Products: TR310 / TR311 / TR311HN / TR313 / TR331 / TR333

| FW version	V.0.0.0000.39

Release date	2021/09/14
New features	1. Added HTTPS on/off and ability to upload certificate via webUI. (Under Network)

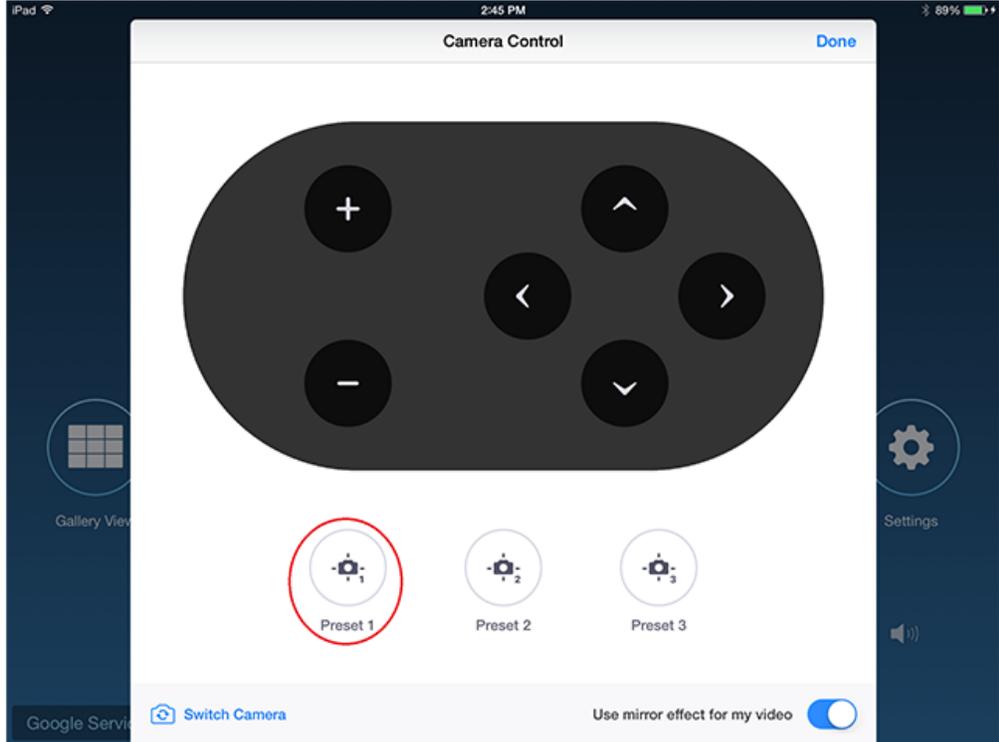
2. Enabled Zoom API, able to set preset1/2/3 in Zoom Rooms SW.

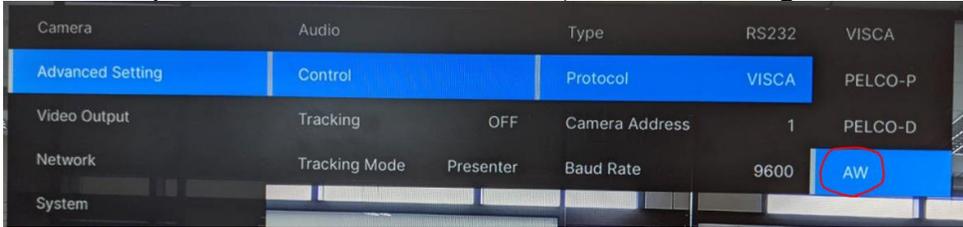
3. Added AW protocol on HDMI OSD menu. (Advanced Settings/Control/Protocol)

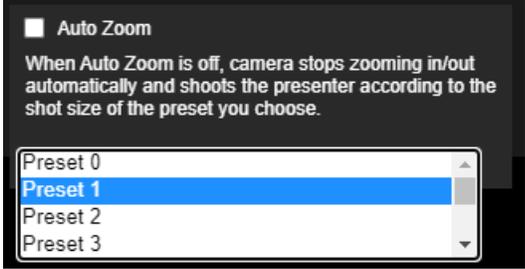
5. Added ability to save preset for people size when Auto Zoom is Turned OFF.

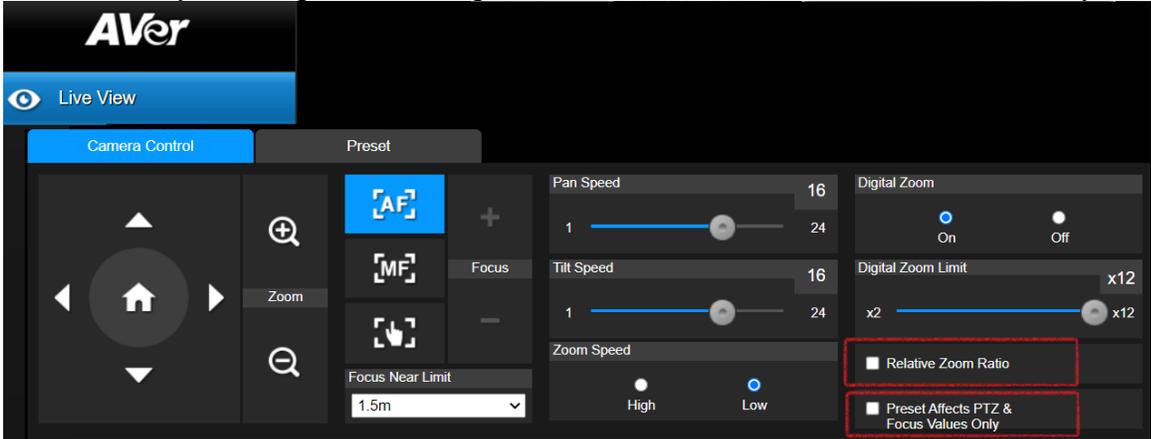
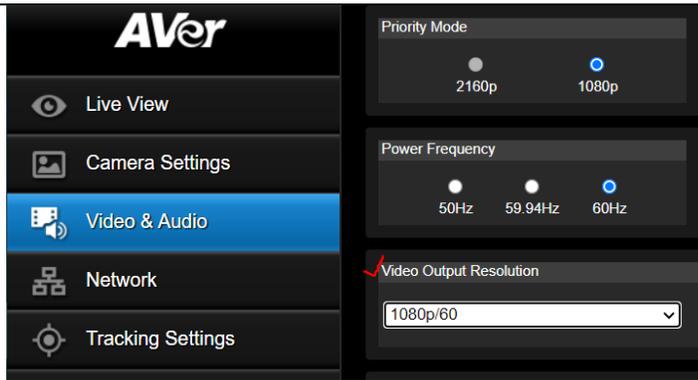
Release date	2021/06/11
New features	1. Added ability to automatically change "pan/tilt speed" relative to Zoom ratio of camera on Web UI, when zoom ratio is higher the pan/tilt speed automatically lowers by itself. 2. Added ability to save preset effects pan/tilt/zoom location and Auto focus value only. 3. Added ability to change "Resolution" of camera on Web UI.

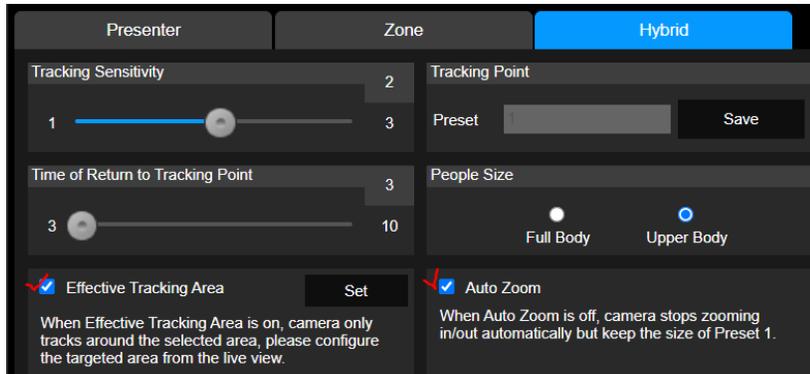
4. Added "Effective tracking area" and "Auto Zoom" setting of Hybrid mode via the Web UI.

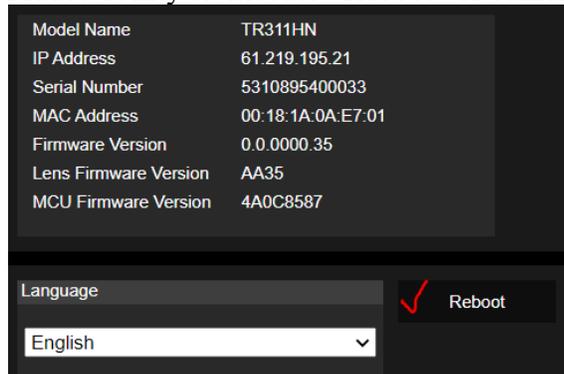
5. Added ability to execute "Reboot" of camera via the Web UI.

Set VISCA Customized Functions ✕

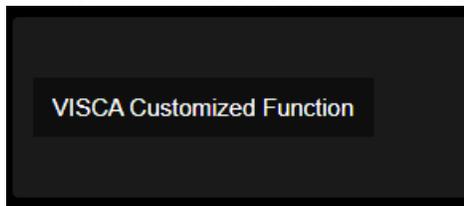
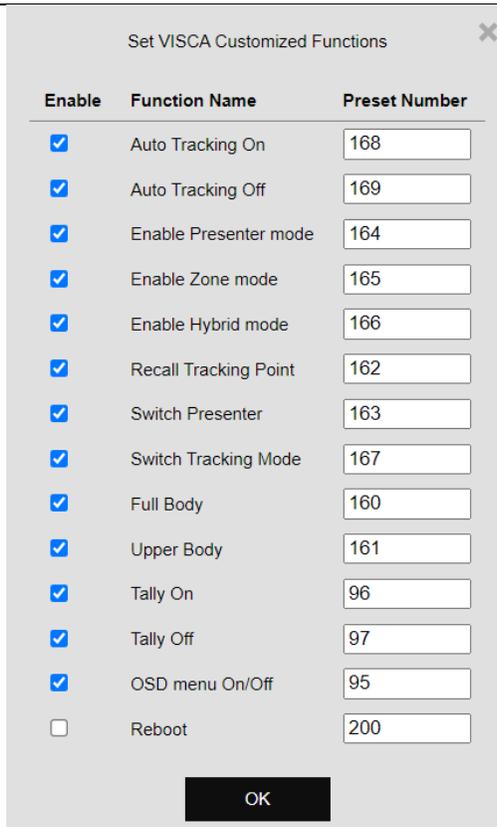
7. Added ability to execute some function via VISCA preset number on Web UI, allows user to execute some function from PTZ Camera Controller (compatible with VISCA)

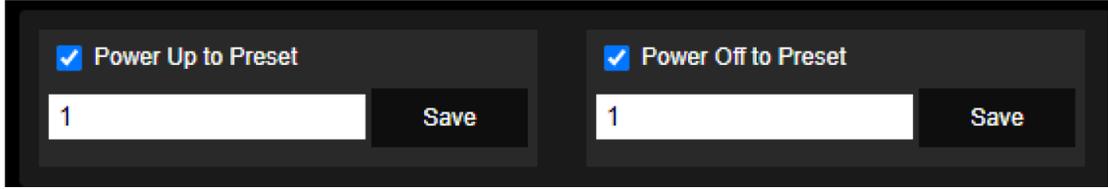
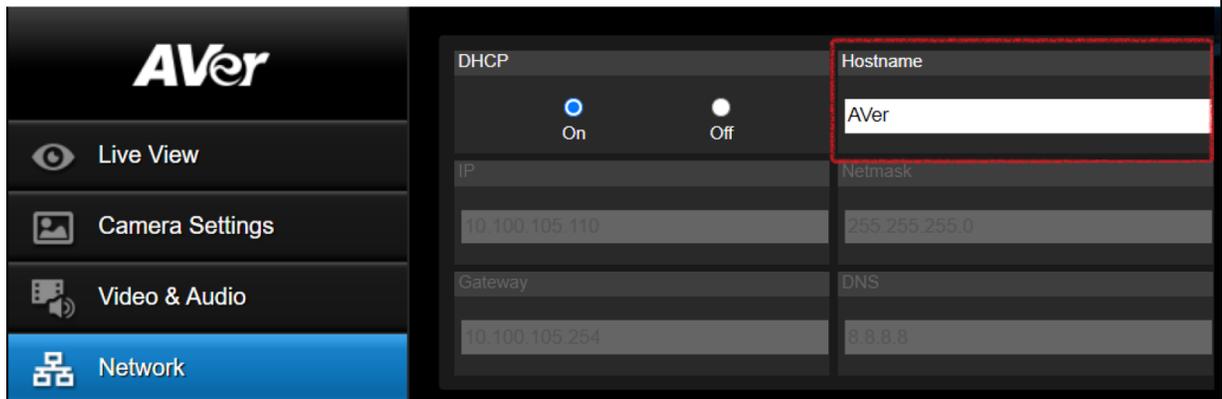
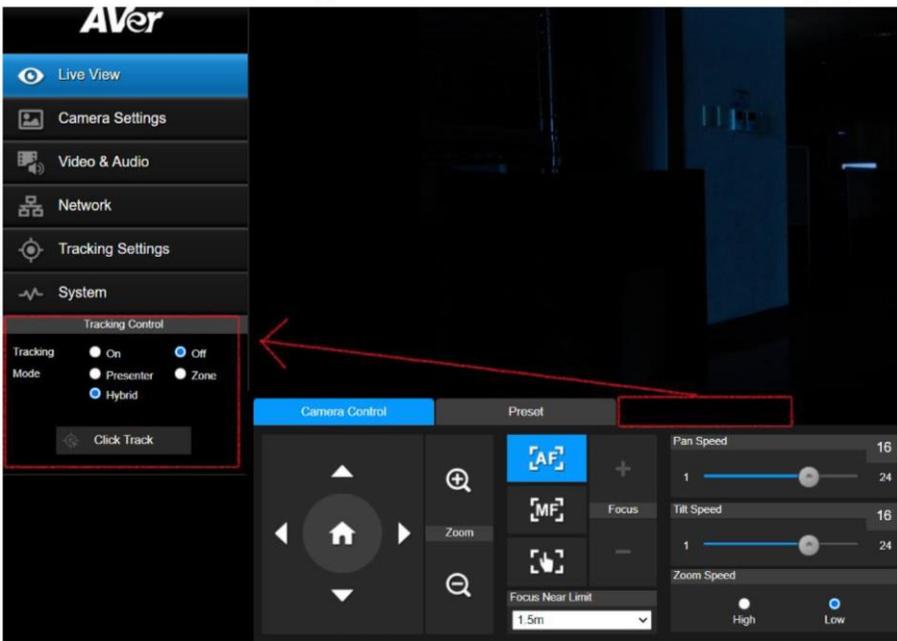
FW version	**V.0.0.0000.30**
Release date	2021/04/01
New features	6. Added Power Up to Preset position setting on Web UI. 7. Added Power Off to Preset position setting on Web UI. 8. Added Tracking mode SET & GET mode commands to the CGI/VISCA command list. 9. Added ability to change "Hostname" of camera on Web UI. 10. Relocated the Tracking Controls to the Main Menu on the Web UI.

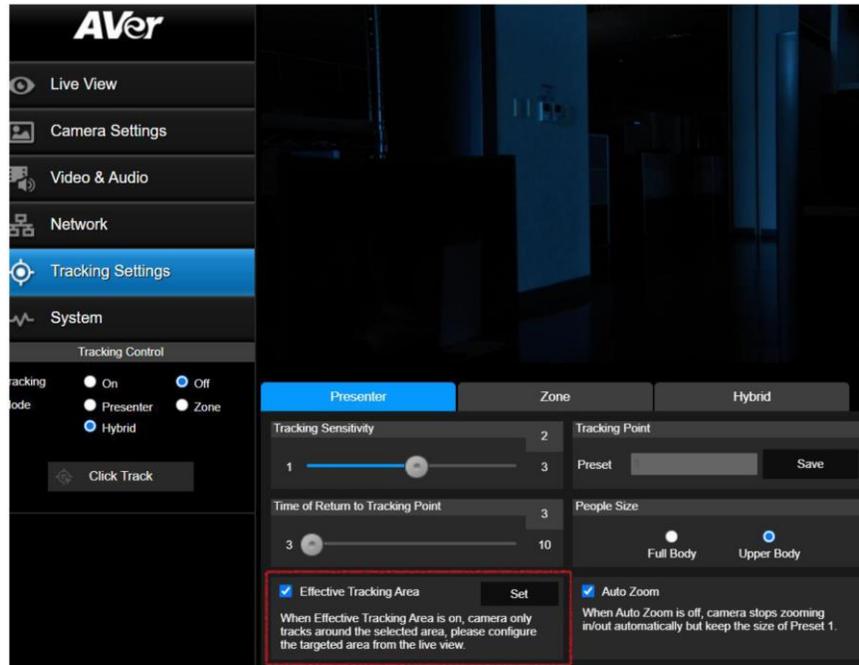
11. Added Effective Tracking Area function in Presenter Mode. If this is checked, the camera can be programmed to only track the subject within a predefined area of its view.

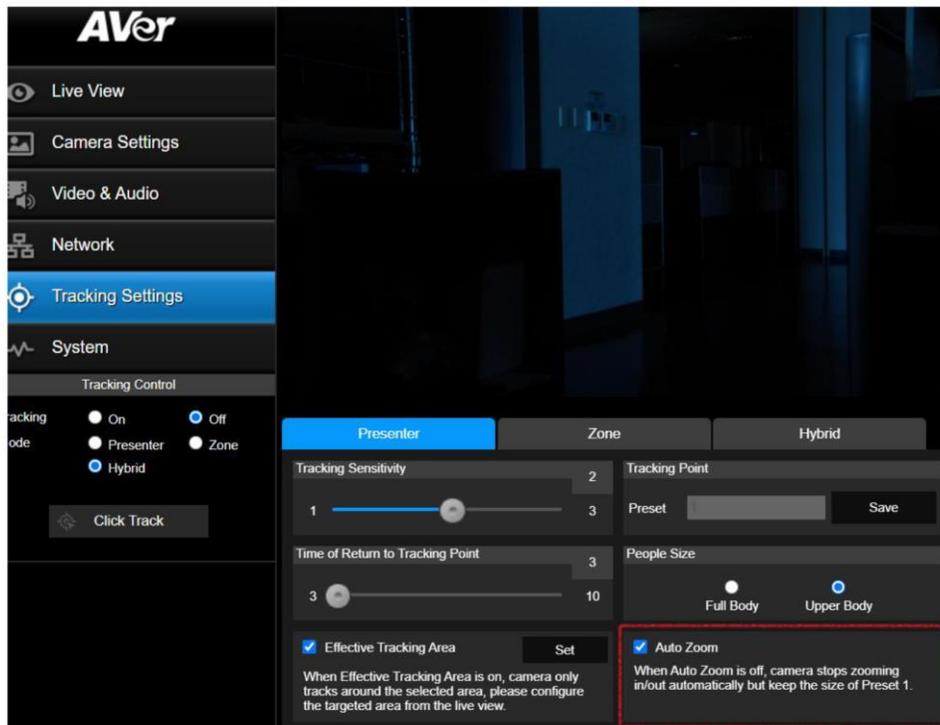
12. Added Auto Zoom Enable/Disable function in Presenter Mode. When checked, the initial zoom value once subject is acquired is preserved throughout the tracking experience.

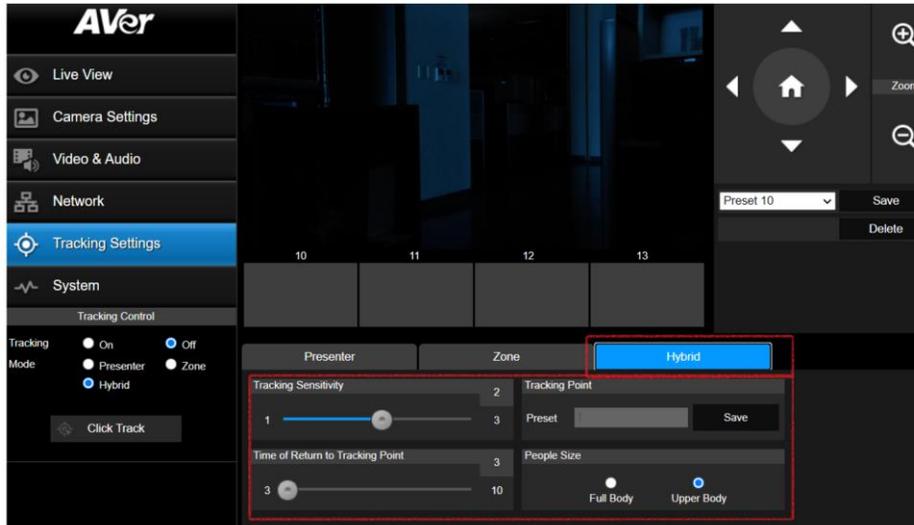
13. Added a new "Hybrid Mode" Tracking feature. This feature combines the best features of both the Presenter Mode and the Zone mode. Preset 10 through 13 is preserved for the Zone mode feature where the camera will automatically toggles to Zone mode whenever

the subject is within those preset zones. When the subject is outside of those predefined zones, the camera automatically switches to "Presenter mode".

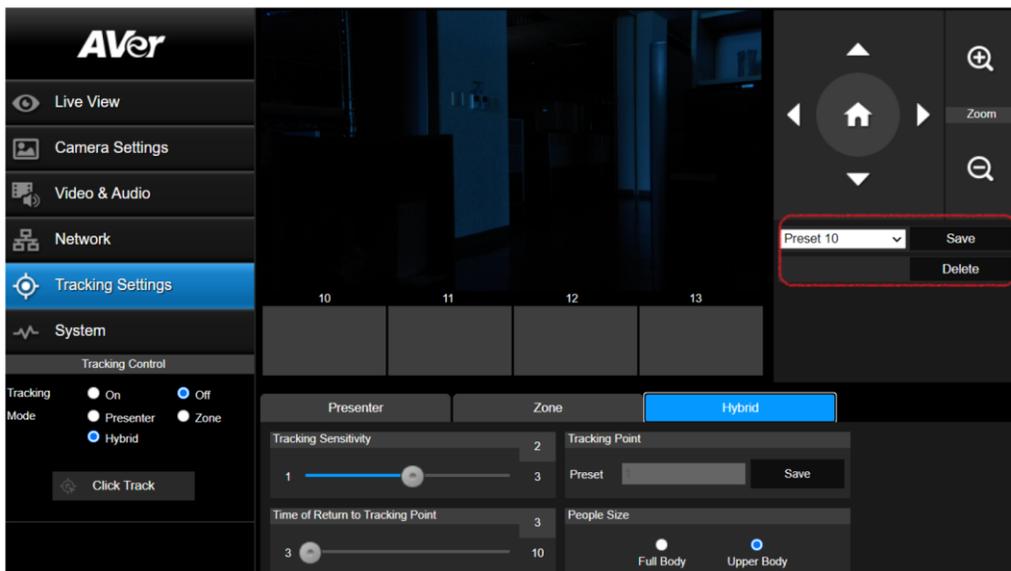
14. Added and improved on the method to "Save/Delete" presets in the Zone and Hybrid Mode setup screen.

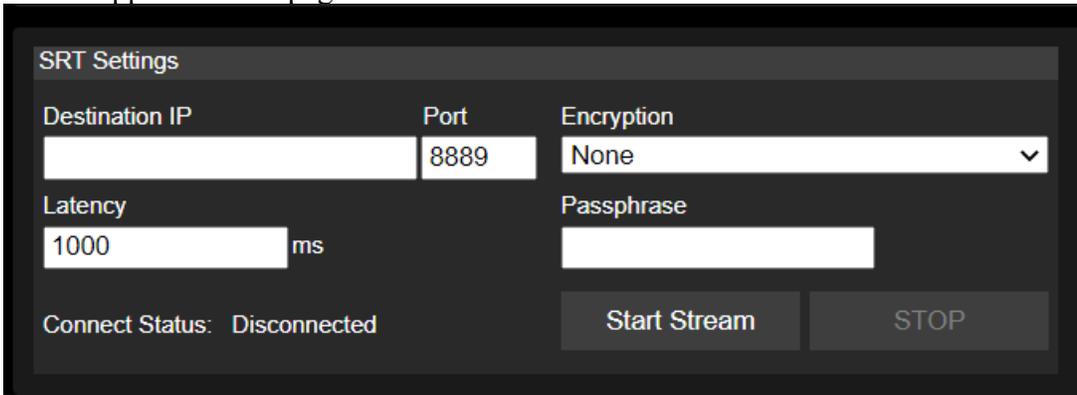
FW version	V.21
Release date	2020/10/26
New features	15. SRT support on web page > Network

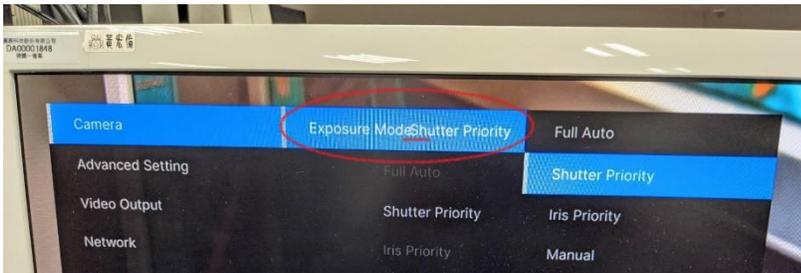
16. Support added for PTZ Management. 17. Support for Captureshare. 18. When Auto Tracking is on, the front panel LED will blink in blue. 19. Long pressing the "Tracking point" on remote control switches the Tracking mode (between presenter or zone). 20. Executing any of these functions "Call preset/ pan/ tile/ zoom" will stop the Auto Tracking feature. 21. Visca control now supports freeze and tracking on/off , Full or Upper body setting.
Improvements	14. When using the "Upper body size" setting the video is enlarged a little for better user experience. 15. Supports UAC function (USB Audio). 16. Fixed bug related to RJ45 LED indicator.
Known Issues	9. Web GUI has known compatibility issue with the Apple MAC Safari browser. Please use the Chrome browser on Apple devices for the meantime. 10. The OSD menu text "Mode and shutter" text issue
